**FINAL REPORT
VALUE ENGINEERING STUDY**

**CDOT Region 2
I-25 North Design Build
El Paso County**

March 2012

BY SOLUTIONS ENGINEERING & FACILITATING, INC.

Wall location north and south of Academy Interchange. The wall would be approximately 7,400 feet in length with the limits approximately 1,700 feet south and 5,700 north of the Academy Interchange.

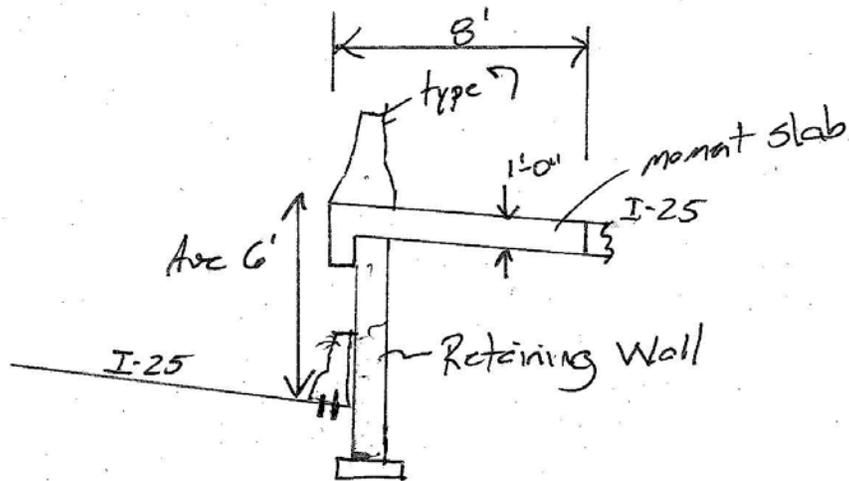
Verify the ultimate can be constructed with the split profile. There is not enough information to determine if the ultimate section can be constructed with the split profile if the split profile was allowed to remain further investigation would have to be done at a later time. This would be done prior to releasing the proposal to the Design Build Teams.

If the RFP to the Design Build Teams allows the split profile, CDOT would also require the Design Build Team to verify the ultimate section can be built with the split profile.

The cost of the wall could be more than matching profiles. Utilizing the cross-sections the average height of the wall was determined to be approximately 6-feet. The unit costs used are \$50 per square foot for MSE Walls and \$60 per square foot for Cantilever Wall. If the wall is constructed a moment slab would be required for the elevated roadway.

The cost of the moment slab is approximately \$1.4 million (see sketch) and would be added to the cost of the MSE and cantilever wall.

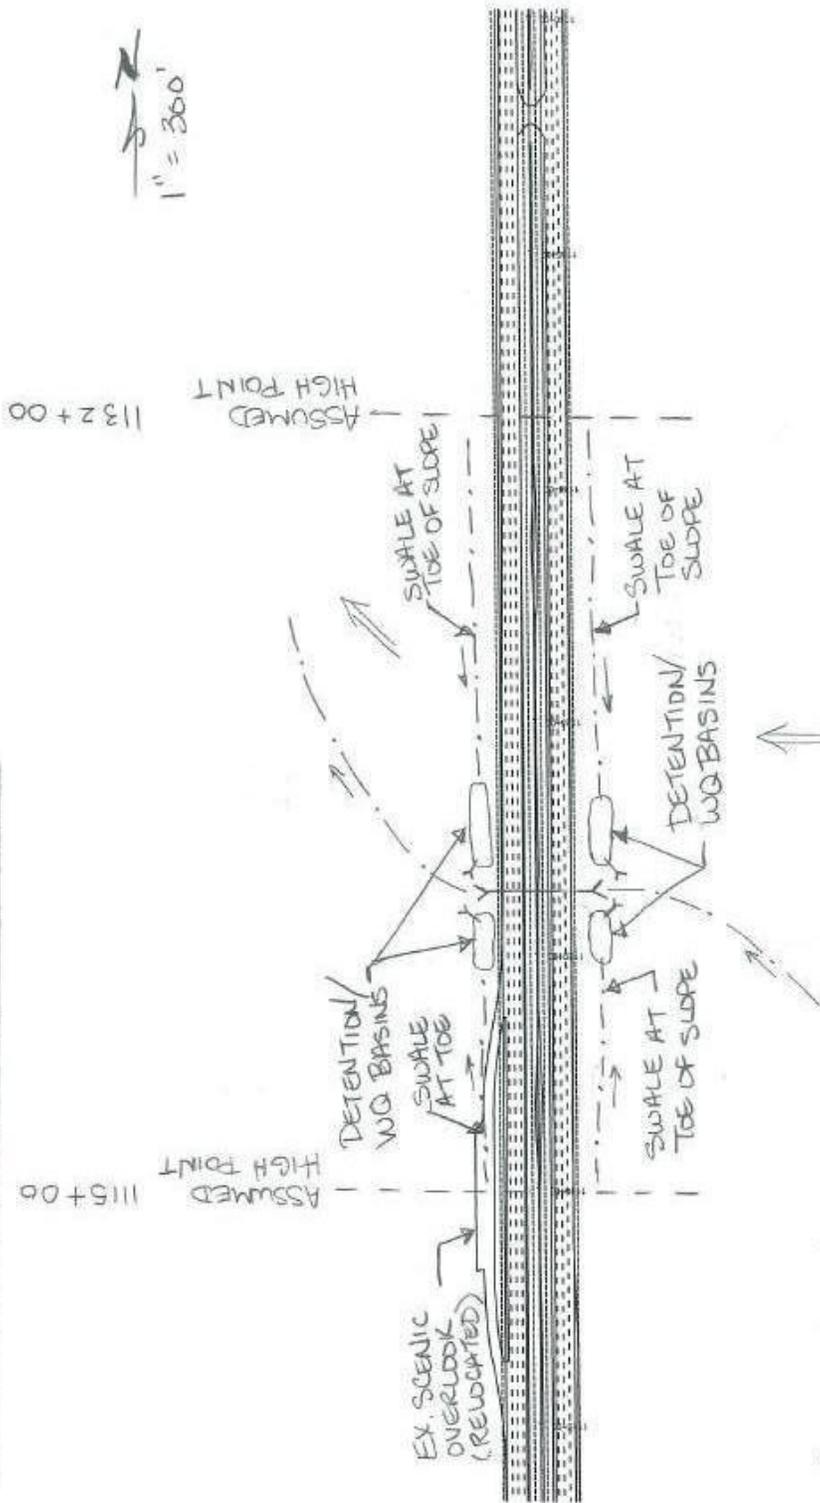
EVALUATION
Idea Number: 01-003 Idea Description: Install a valley pan along outside shoulder to intercept and convey water quality and 100-year flows.
Advantages of alternative concept: <ol style="list-style-type: none">1. Roadway runoff is isolated from offsite flow2. Roadway runoff is elevated up near shoulder elevation to better isolate and convey water to one treatment facility.3. Fewer detention/WQ facilities requiring less CDOT maintenance resources.4. Modified Gutter Type 2 12:1 side slopes do not cause a clear zone safety issue
Advantages of original concept: <ol style="list-style-type: none">1. Potentially shorter tie in to toe of slope2. No storm sewer3. Easier to build safety edge
Risks of implementing alternative concept: <ol style="list-style-type: none">1. Maintenance force concerns about using v-pan along outside shoulder

- SAG IN HWY AT CULVERT
 - LONGITUDINAL SLOPE = 2%
 - BRIARWOOD TO INTERQUEST CROSS SECTION
1103+00 TO 1140+00 WITH 2% CROSS SLOPE
 - SCENIC OVERLOOK RELOCATED
- PREVAILING DRAINAGE SLOPES EAST TO WEST
 - ADEQUATE ROW FOR SWALE AND DETENTION/WQ BASINS

ALTERNATIVE CONCEPT - ONLY TREATING ADDED IMPERVIOUSNESS

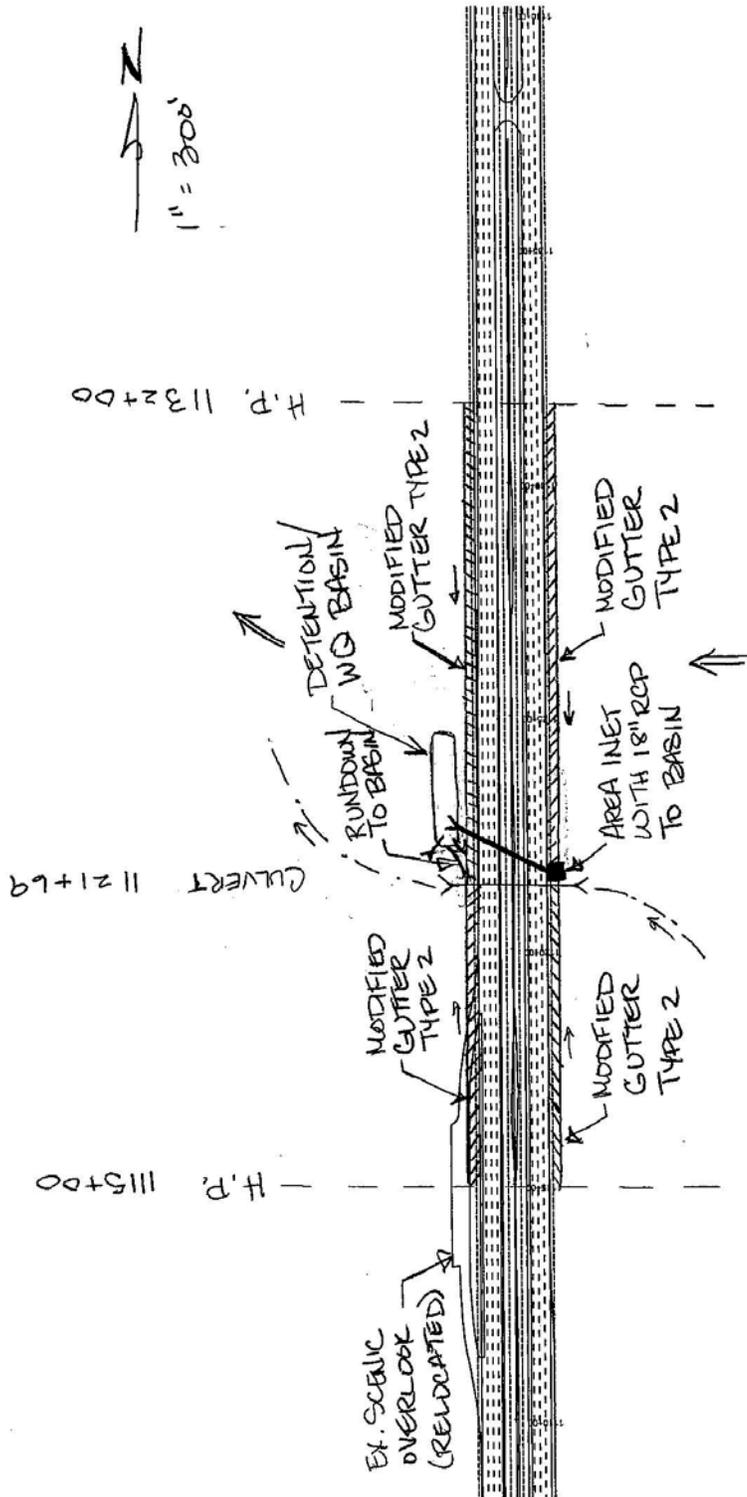
- SAG IN HWY AT CULVERT
- LONGITUDINAL SLOPE = 2%
- BRIARWOOD TO INTERQUEST CROSS SECTION 1103+00 TO 1140+00 (NO HOV LANES) WITH 2% CROSS SLOPE
- SCENIC OVERLOOK RELOCATED
- PREVAILING DRAINAGE SLOPES EAST TO WEST
- MODIFIED GUTTER TYPE 2, SHOULDER AND 4' OF OUTSIDE LAKE CAPACITY = 7.8 CFS
- TREATING ONLY ADDED IMPERVIOUS AREA = 37 SF/LF $\Rightarrow Q_{100} = 0.73 \text{ CFS} / 100 \text{ LF}$

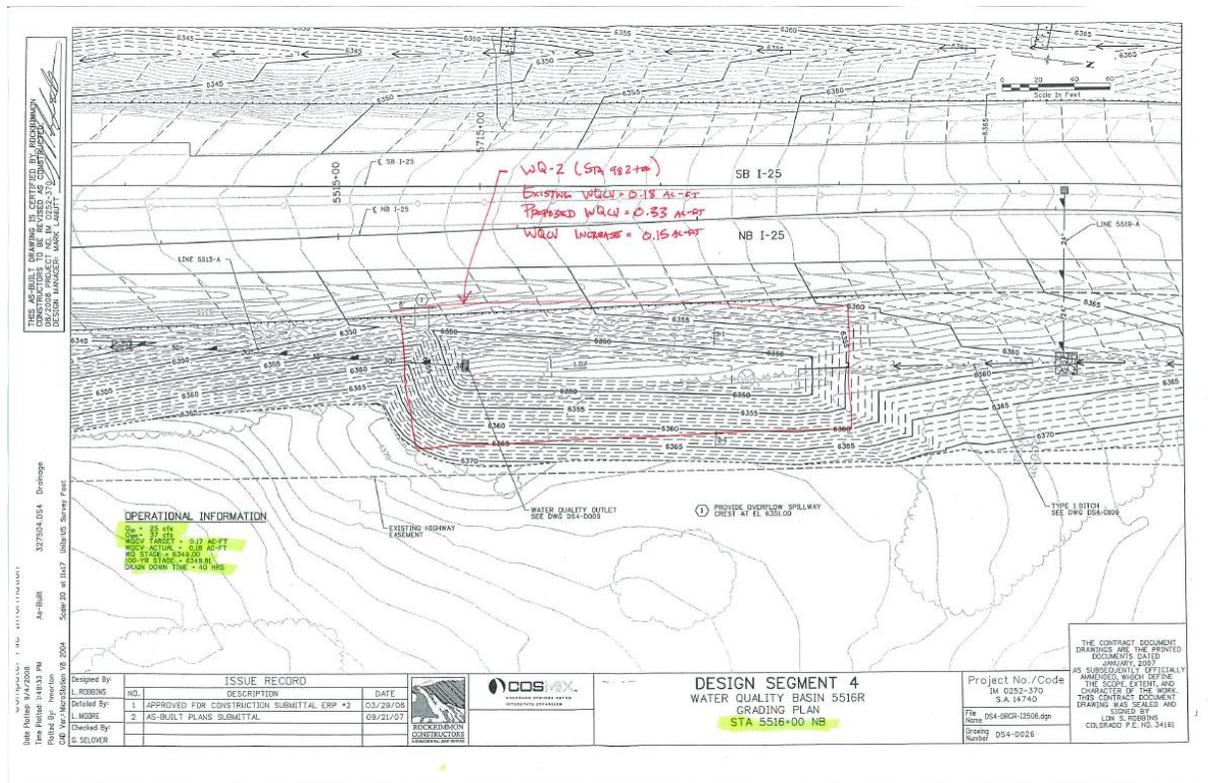
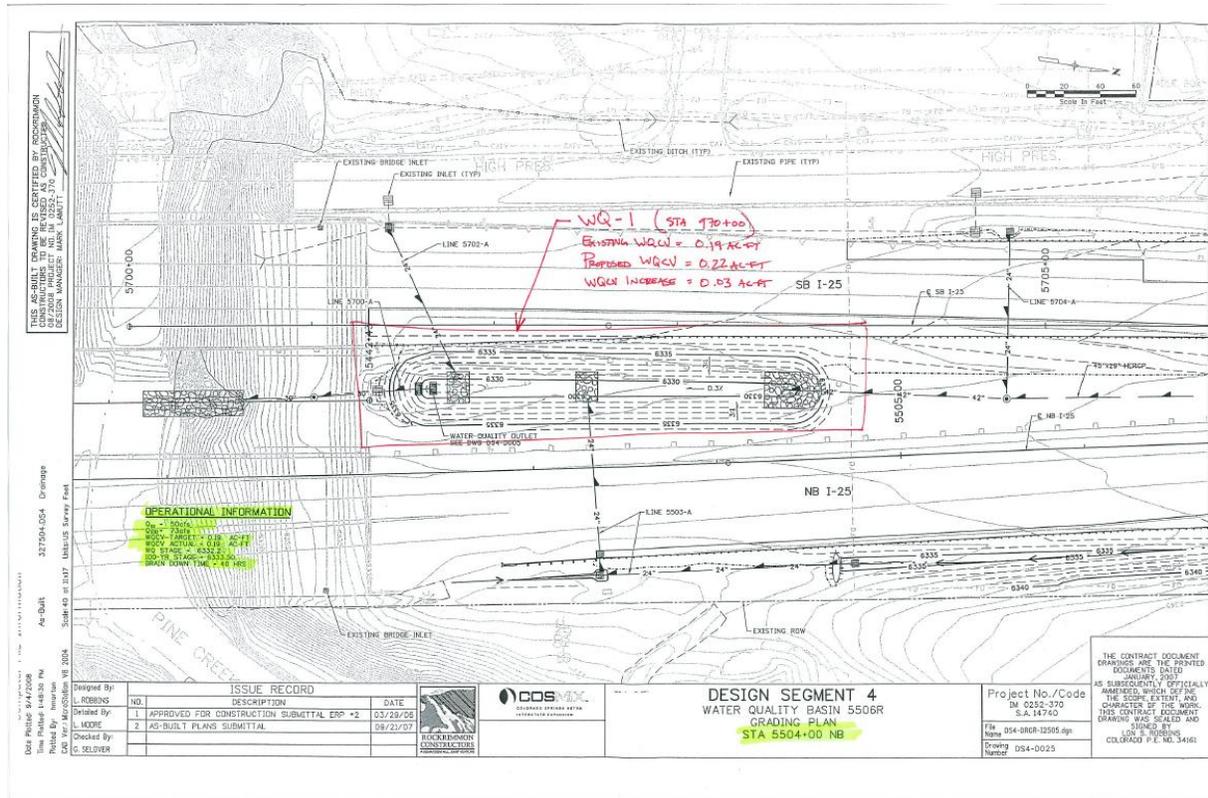
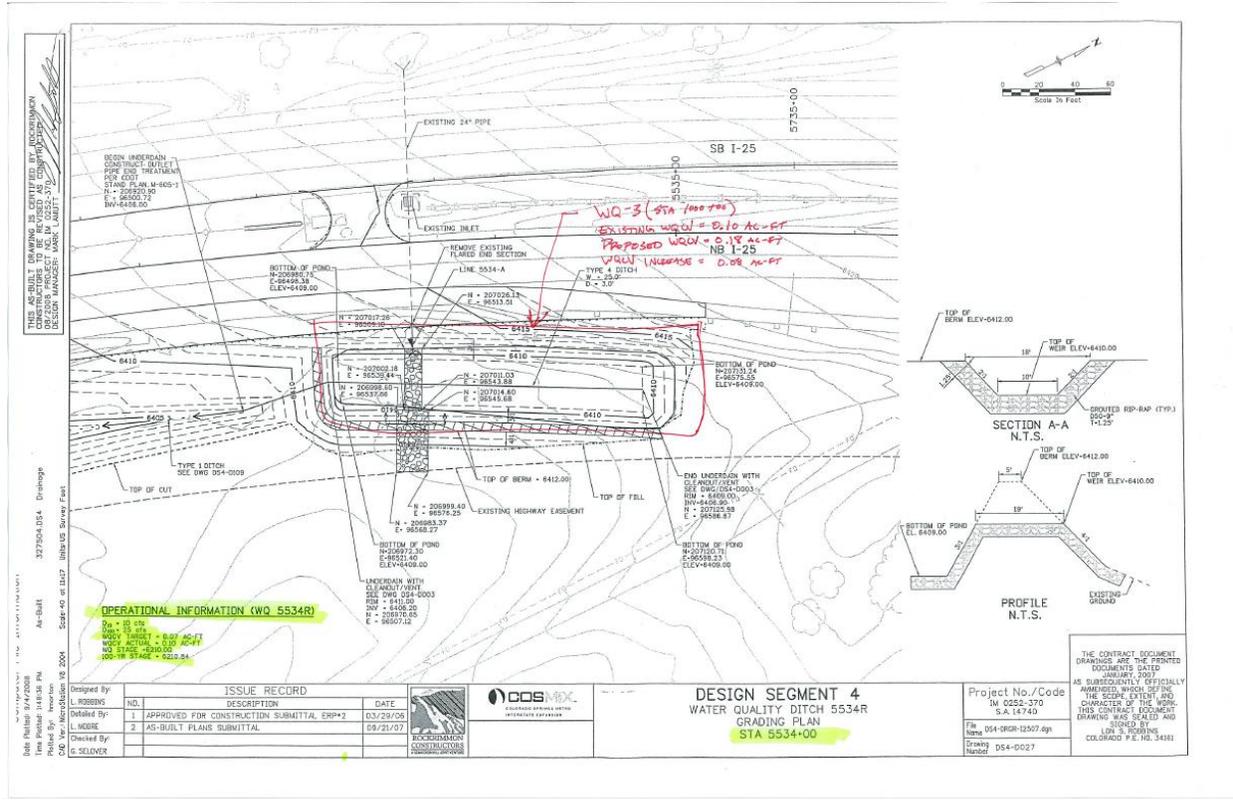
Two conditions were developed for the water quality of the roadway drainage near Pine Creek: (1) Construct New Facilities and (2) Retrofit Existing Facilities. A summary of each and assumptions are discussed below, a summary table is provided, and some annotated plans are also included within this document.

It is assumed that the proposed roadway widening would not affect the location of the existing facilities and thus the existing basins could be retrofitted. The costs include modifications to the orifice plate and minor grading to increase the basin size. Due to widening to the outside, WQ-1 is likely the only basin that could be retrofitted.

Note: Throughout the corridor, not just near Pine Creek, existing water quality basins should be utilized wherever they can.

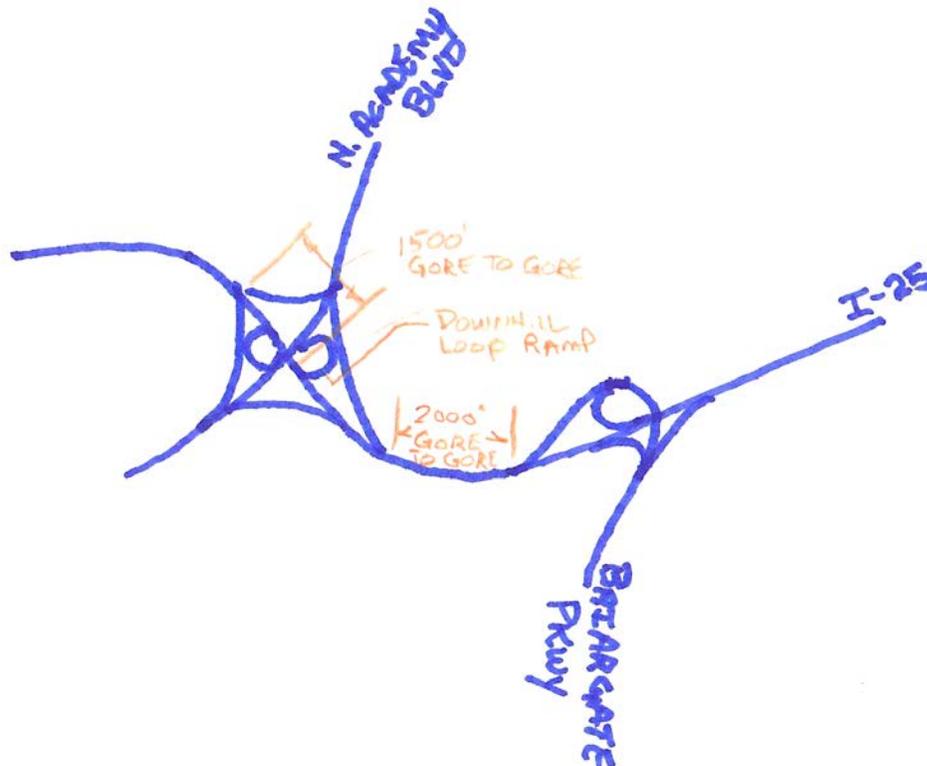
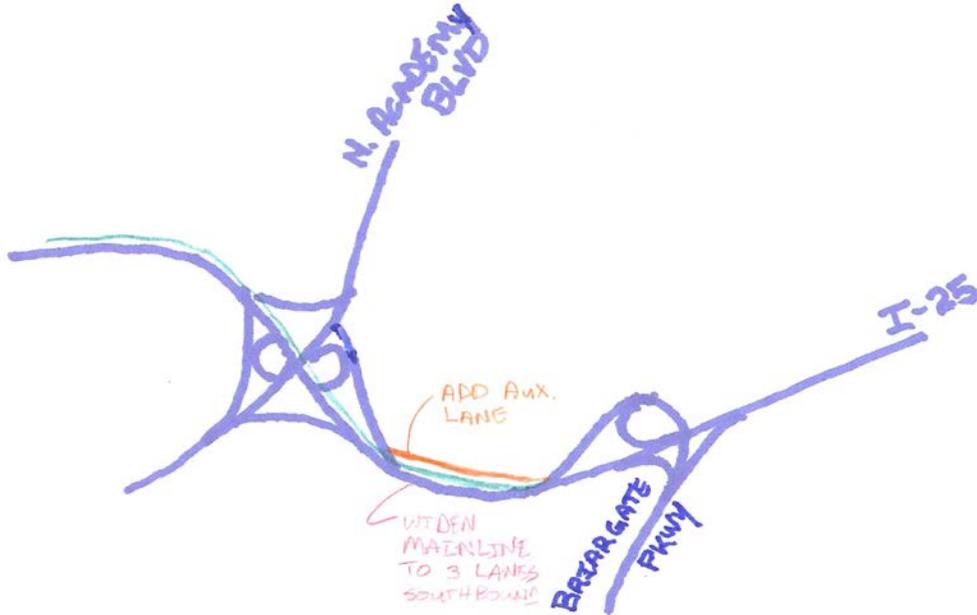
The southbound ramps at Briargate Pkwy and North Academy Blvd currently provide for very limited substandard weaving distances. With four gores in less than 6,500 feet, mainline congestion and safety are compromised, especially with less than 2,000 feet between the Briargate and Academy interchange gores.

The North Academy interchange is currently configured as a Two-Loop Partial Cloverleaf (ParClo) interchange. The current southbound loop ramp gore creates distractions to southbound I-25 drivers as users of the loop ramp are highly visible from southbound I-25 drivers. Many times the southbound I-25 drivers can see the loop ramp drivers accelerating around the loop ramp. I-25 drivers tend to move over a lane to allow for the loop drivers to enter the highway and immediately drift over into the southbound through lanes. This lane shift of the I-25 drivers poses safety concerns and increases mainline congestion. This “condition” will be worsened under the EA’s proposed action (base case) by further tightening the radius of the loop ramp at the gore point to accommodate the mainline widening. Eliminating the loop ramp could increase mainline capacity, reduce congestion, and provide for a safer access configuration.

There are many options to reconfigure the North Academy Interchange and to eliminate the short gore to gore spacing along this stretch of southbound I-25. Options may also include modifications to the Briargate Interchange in combination with improvements of the Academy Interchange. These combined interchange options are included in Supplemental Recommendation 01-035 “Construct a Collector/Distributor (CD) roadway between southbound Briargate Pkwy and North Academy Blvd”.

Alternative 1 – Single Loop ParClo

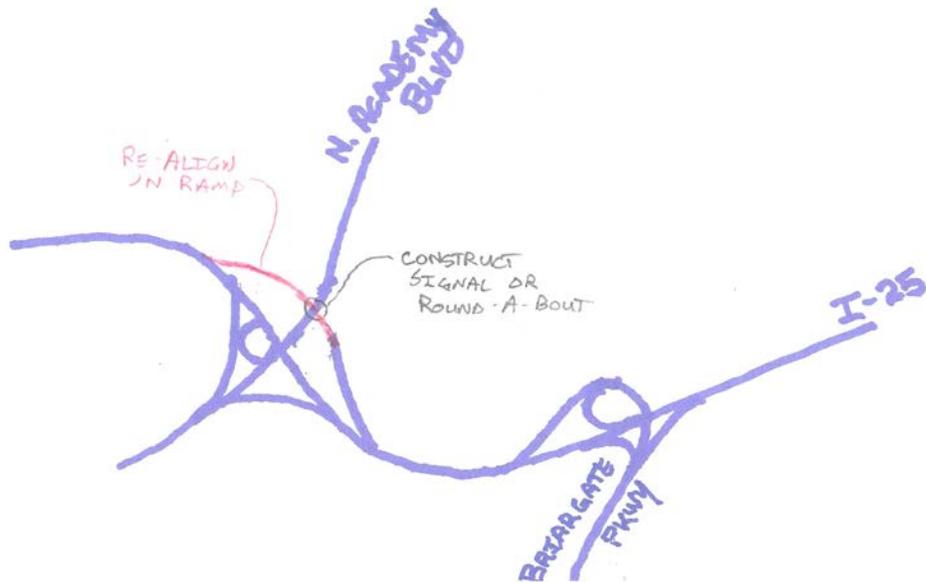
The Alternatives suggested in this Supplemental Recommendation are focused on lower cost options that utilize the existing Academy bridges and have minimal impacts, including little or no additional right of way. Low cost alternatives may include but are not limited to:

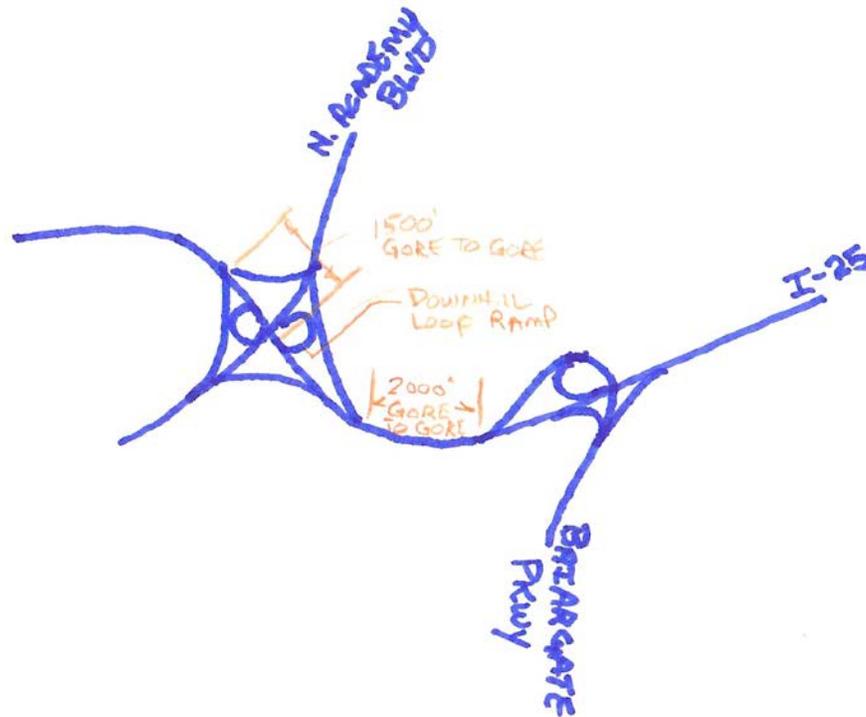
Reduce congestion and improve safety southbound between Briargate Pkwy. and North Academy Blvd interchanges by modifying ramps into a Collector/Distributor (CD) road.

Alternative 1

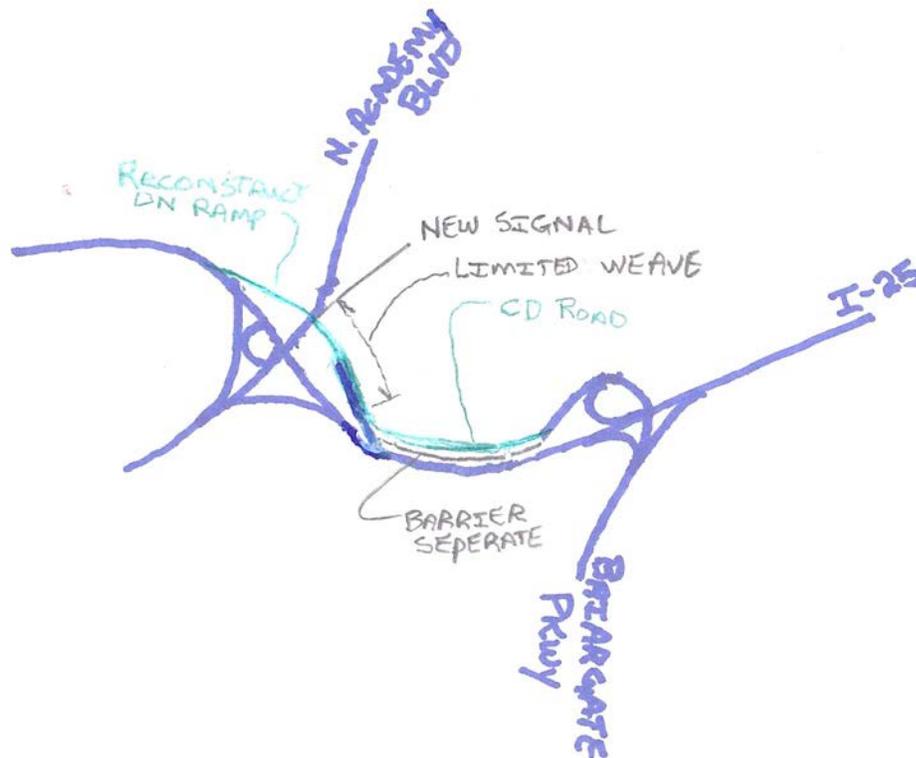
Alternative 1 suggests constructing the CD system and keeping the Academy off ramp at its current location. This will provide for limited weaving opportunity after the off ramp and CD road combines, causing a potential issue with CD road users weaving across the Academy off ramp users to make the eastbound turn at academy.
